Docket No. 50-272

October 17, 1979  
IE Bulletin No. 79-13  
Revision 2  
Page 1 of 5

CRACKING IN FEEDWATER SYSTEM PIPING

FIGURE 1  
FEEDWATER PIPE ELBOW TO STEAM GENERATOR  
NOZZLE INSTALLATION (DC COOK)

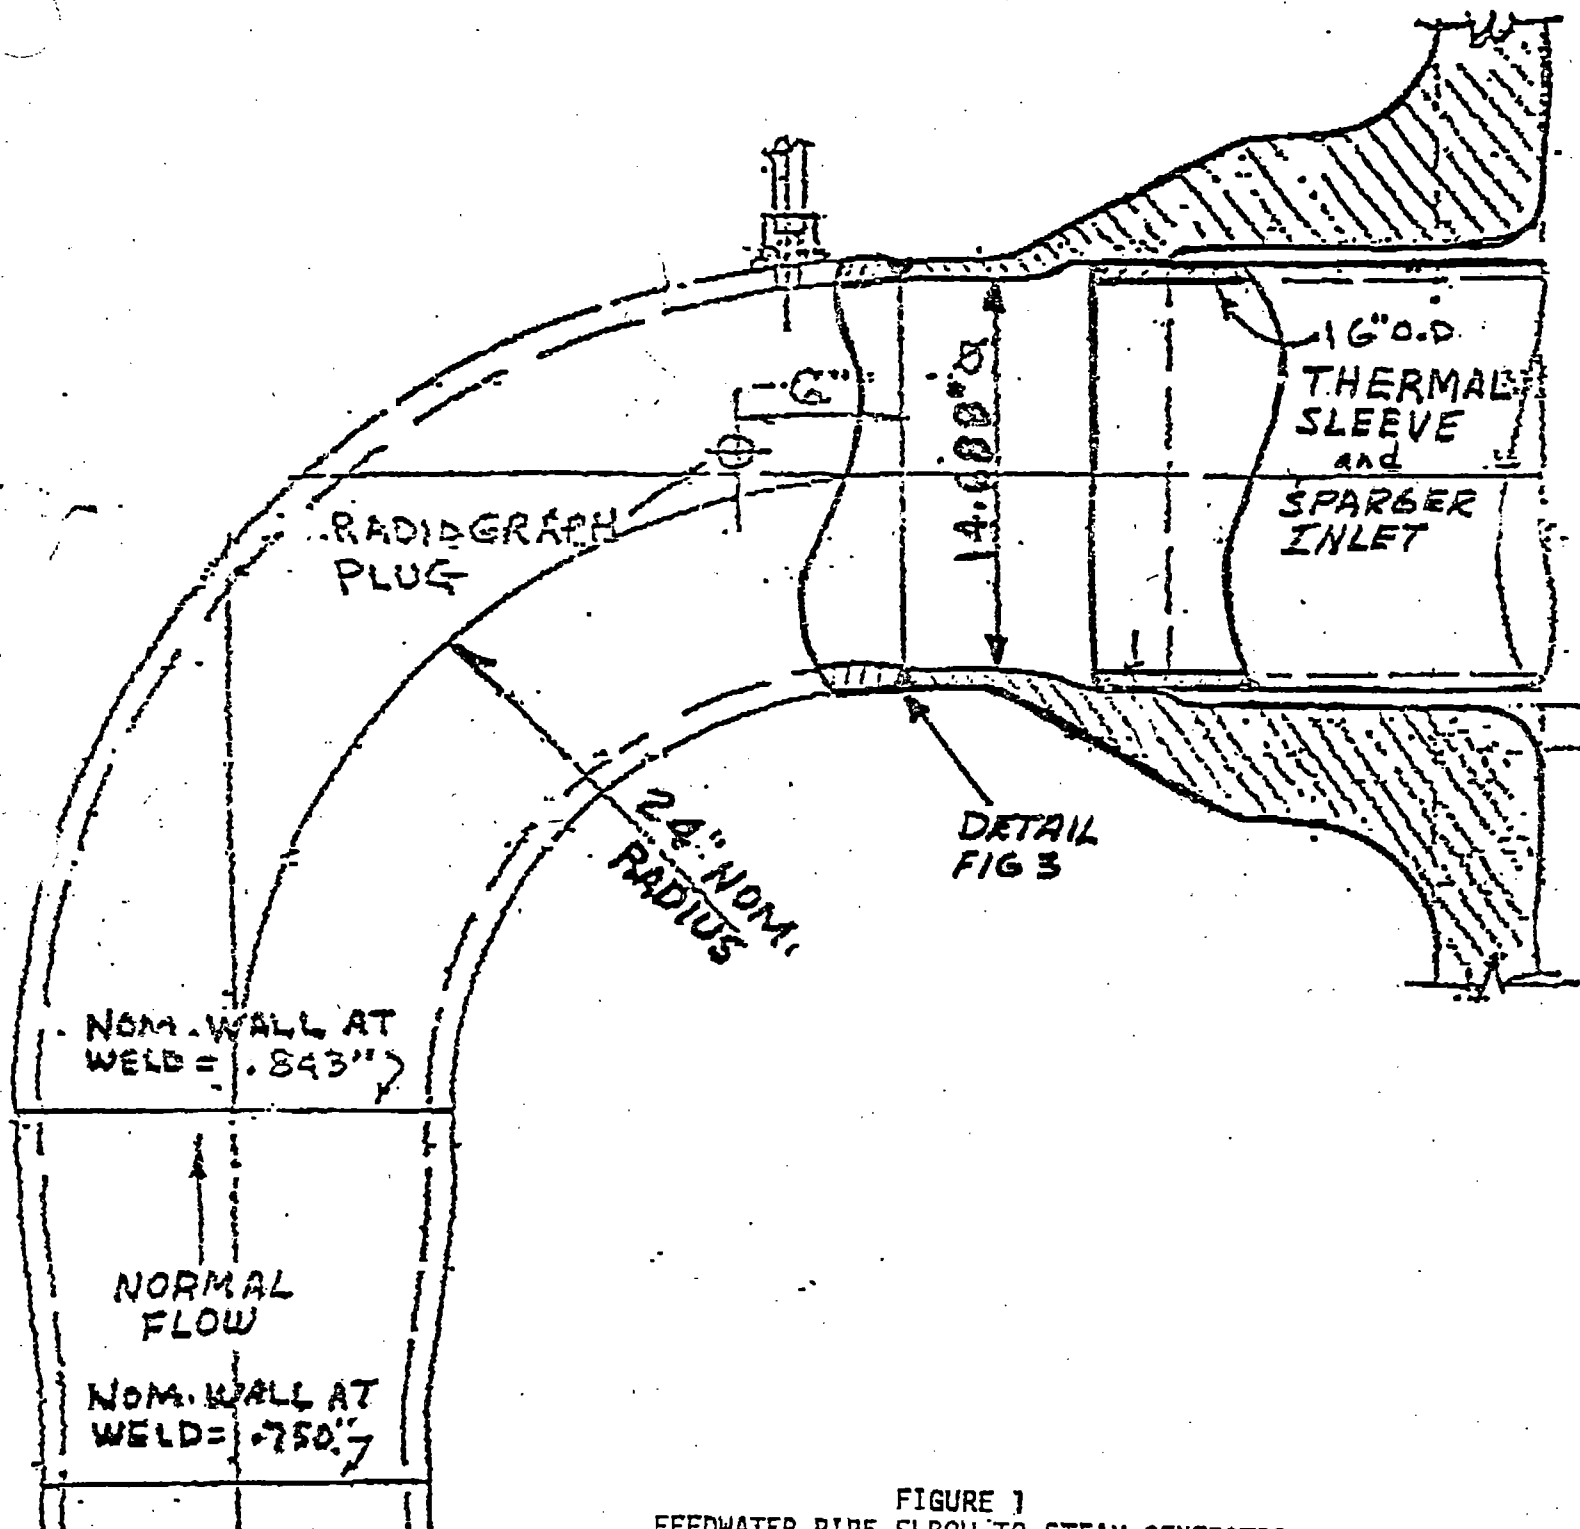
The feedwater nozzle-to-pipe configurations for D. C. Cook and for San Onofre are shown on the attached figures 1 and 2. A typical feedwater nozzle-to-pipe weld joint detail showing the principal crack locations for D. C. Cook and San Onofre are shown on the attached figure 3.

FIGURE 3  
TYPICAL FEEDWATER PIPE TO NOZZLE  
WELD JOINT DETAIL  
( 1 CE )

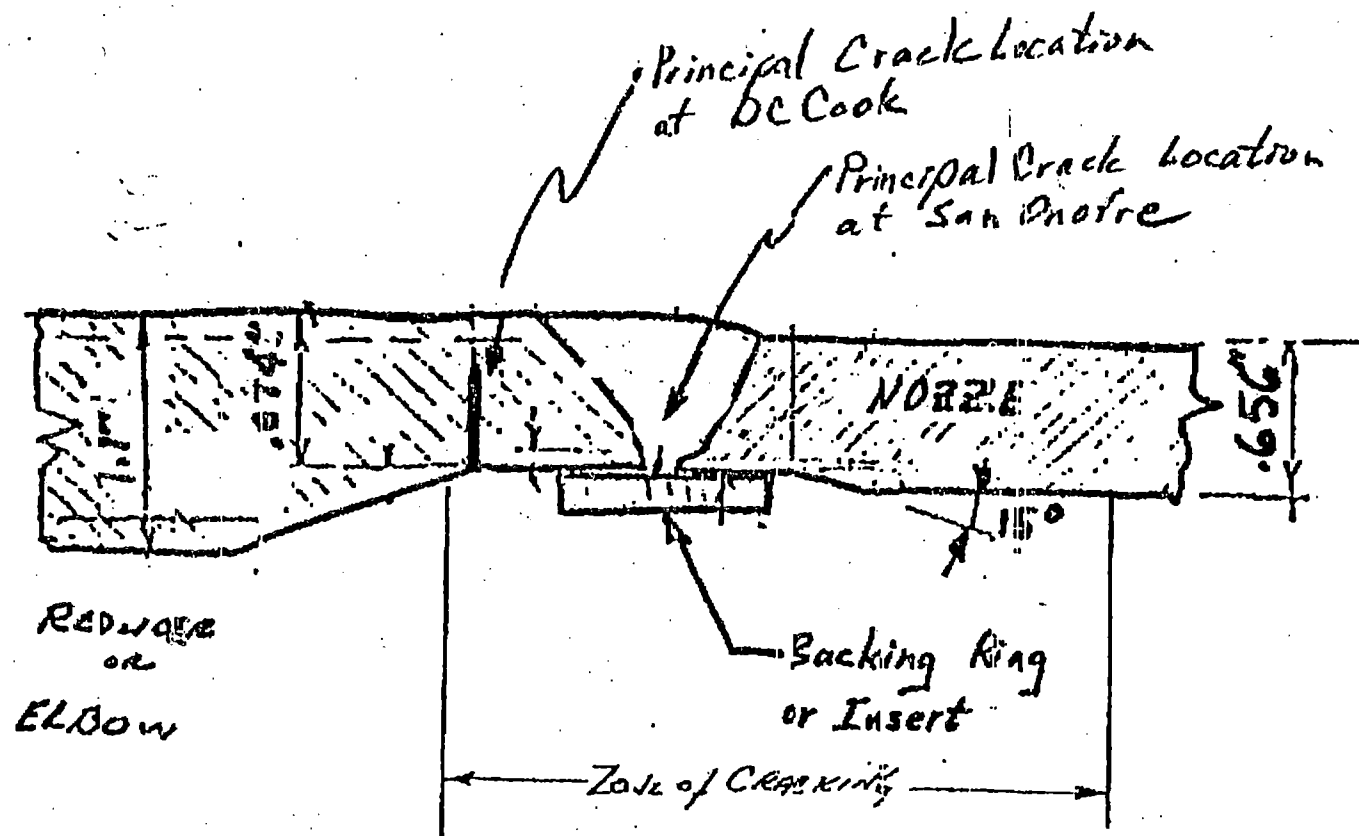
- a. Perform radiographic examination, supplemented by ultrasonic examination as necessary to evaluate indications, of all feedwater nozzle-to-pipe welds and of adjacent pipe and nozzle areas (a distance equal to at least two wall thicknesses). Evaluation shall be in accordance with ASME Section III, Subsection NC, Article NC-5000. Radiography shall be performed to the 2T penetrameter sensitivity level, in lieu of Table NC-5111-1, with systems void of water.
